**LEBANON PLANNING BOARD  
JANUARY 11, 2021 - 6:30 PM  
REMOTE VIA MICROSOFT TEAMS  
LEBANONNH.GOV/LIVE**

**Jolin Salazar-Kish,  
8-10 & 14 Bank Street  
(Tax Map 92,  
Lots 125 & 124),  
zoned LD  
PB2019-39-SPR**

Staff Memorandum – PB2019-39-SPR – *continued from 12/14/20*

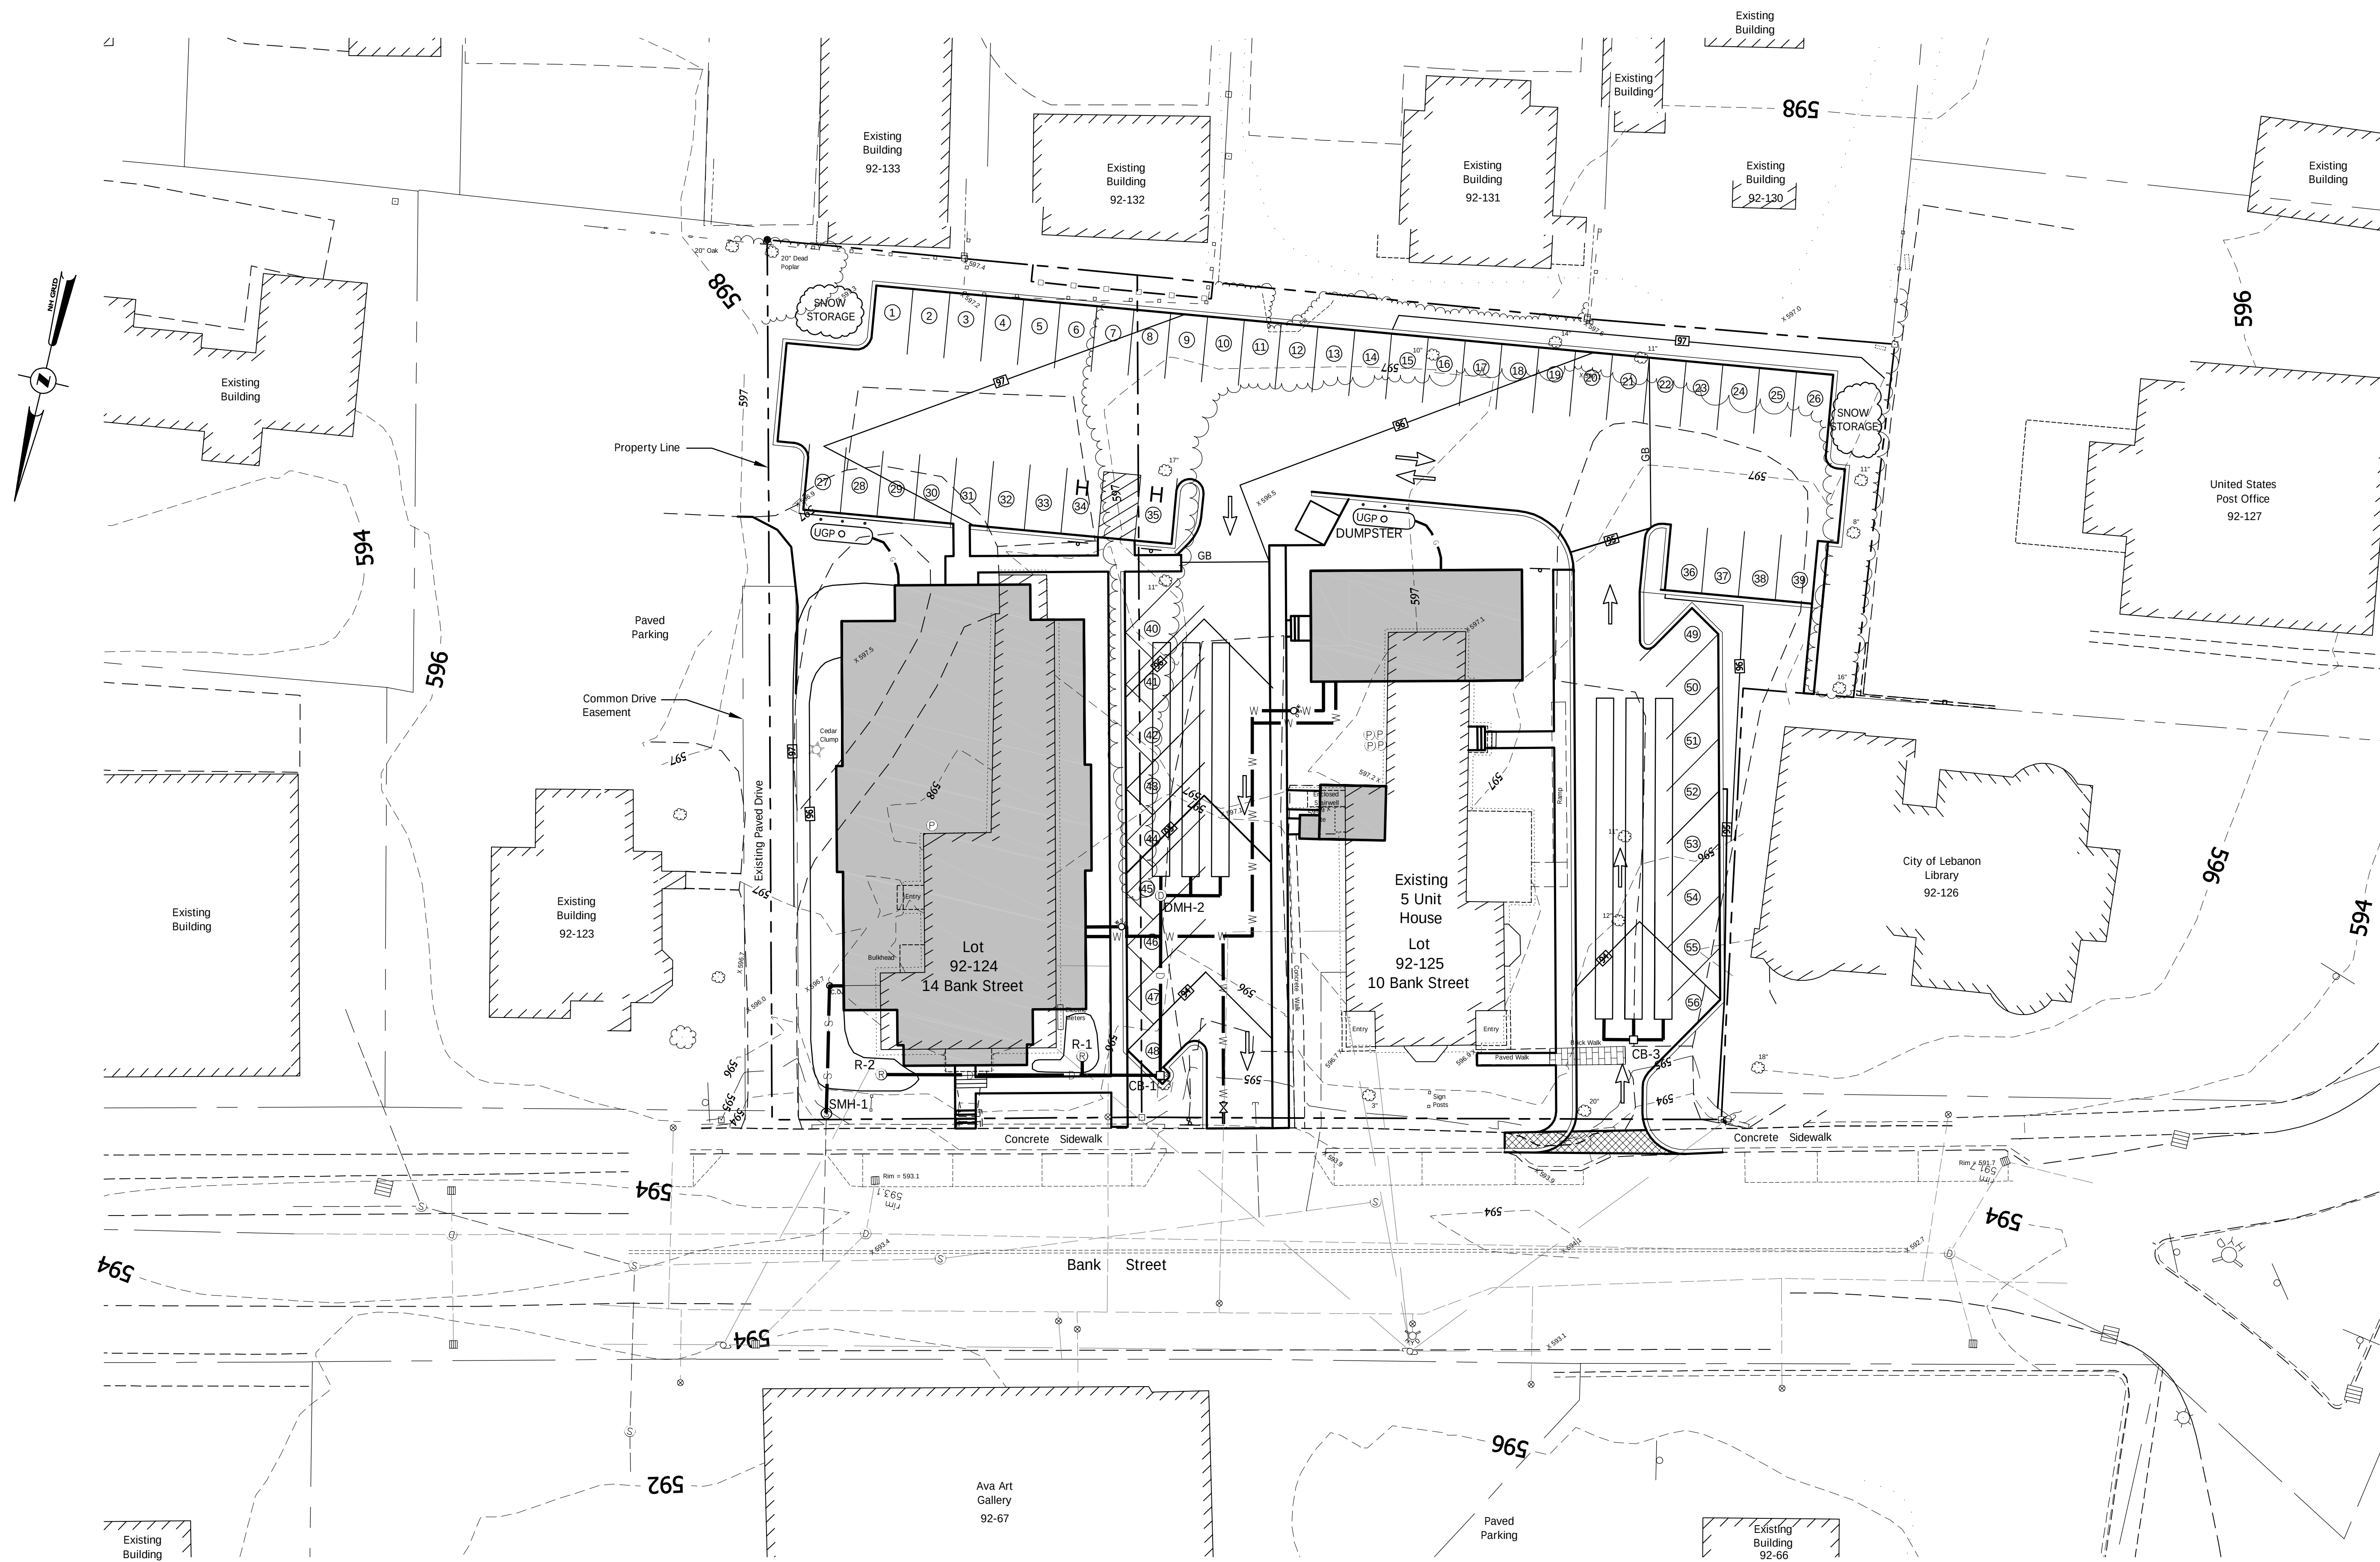
4. Sheet C-1 and Sheet C-6 shows proposed access drive grading, parking lot grading, and site perimeter grading. However, there does not appear to be sufficient proposed grading articulated for the proposed interior walkways/sidewalks, or landscaped areas between existing and proposed buildings, and south of the existing and proposed buildings (10 Bank Street and 14 Bank Street). Staff recommends that the applicant provide more complete and detailed proposed grading in these areas in accordance with Section 5.1.E.6 of the Site Plan Review Regulations.

PROPOSED HOUSING REDEVELOPMENT AT 10 & 14 BANK ST, LEBANON NH  
LANDSCAPE PLAN FOR SITE PLAN REVIEW

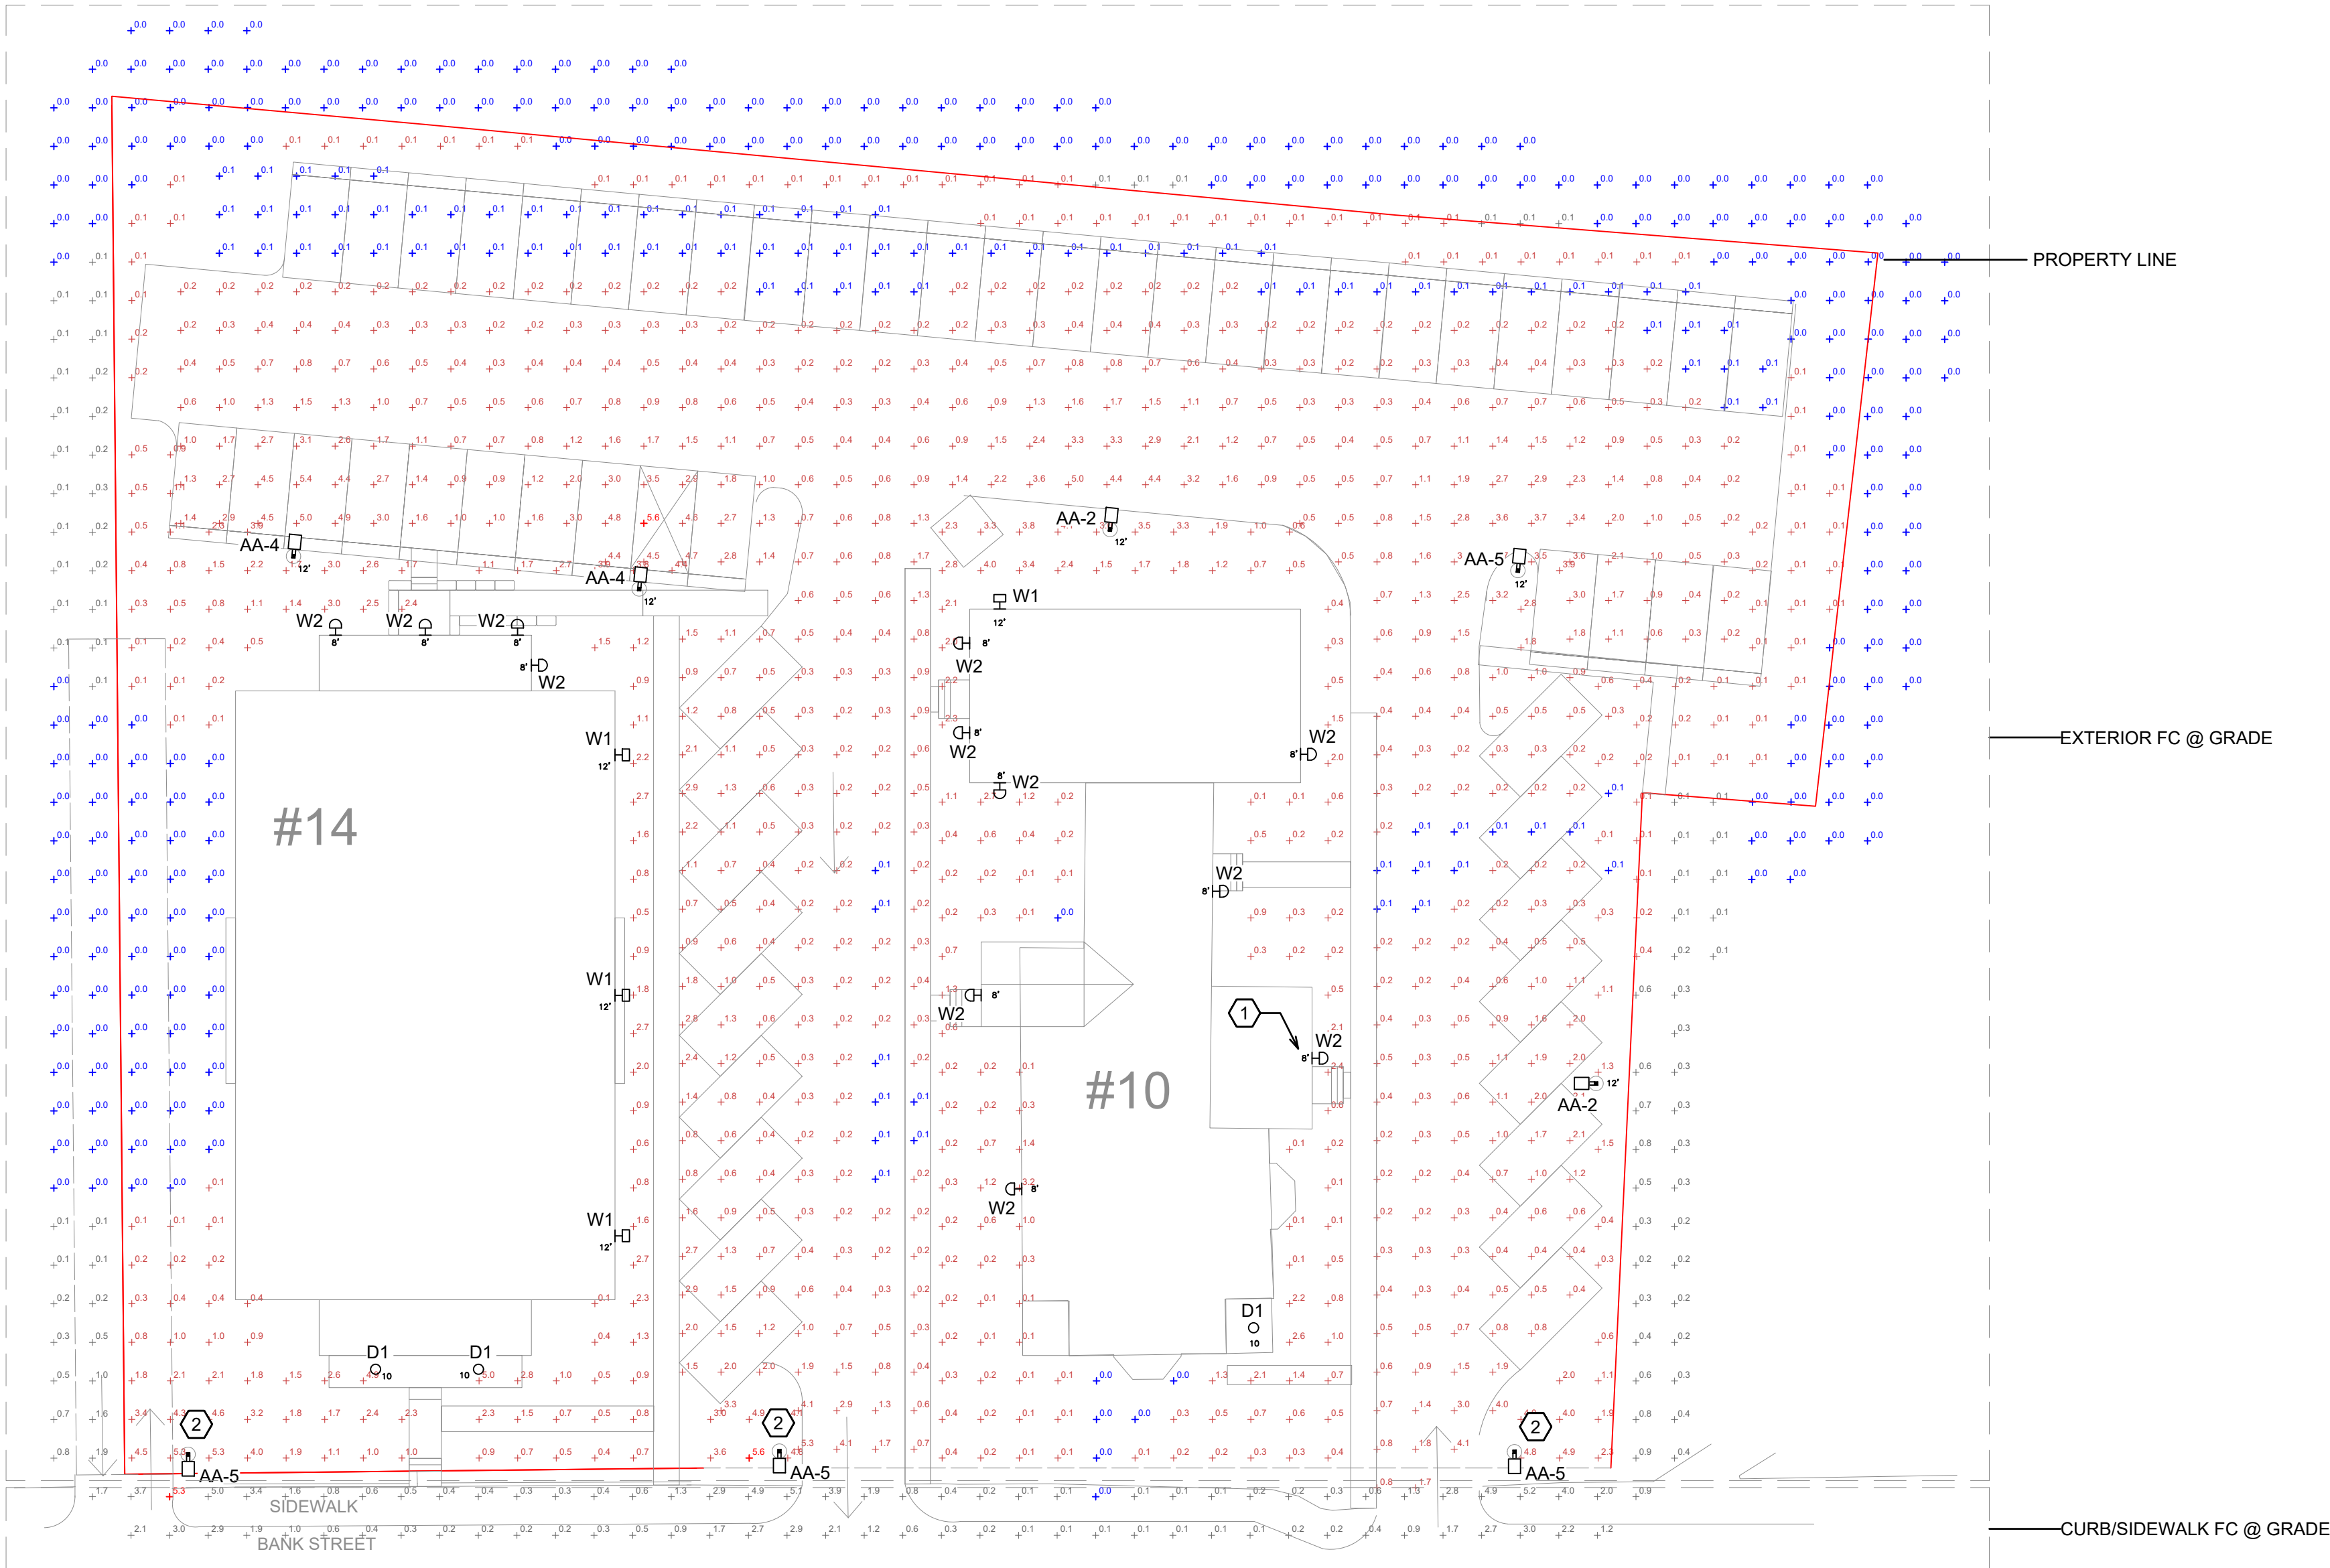
The landscaping plan (Sheet 7 of the attached plan set) should be updated to:

1. Demarcate the 19,121 sf parking area so that staff can verify compliance with the parking shading requirements set forth in Section 6.2.E of the Site Plan Review Regulations.
2. Provide sufficient detail to demonstrate that the AC compressors and dumpster are screened in compliance with the screening requirements of Sections 6.2.B.8 and 9.
3. Remove the existing building footprints.
4. Identify the dashed lines depicted at the rear of parking spaces and the dashed line moving diagonally in a southwestwardly direction towards the southern boundary of the post office lot.
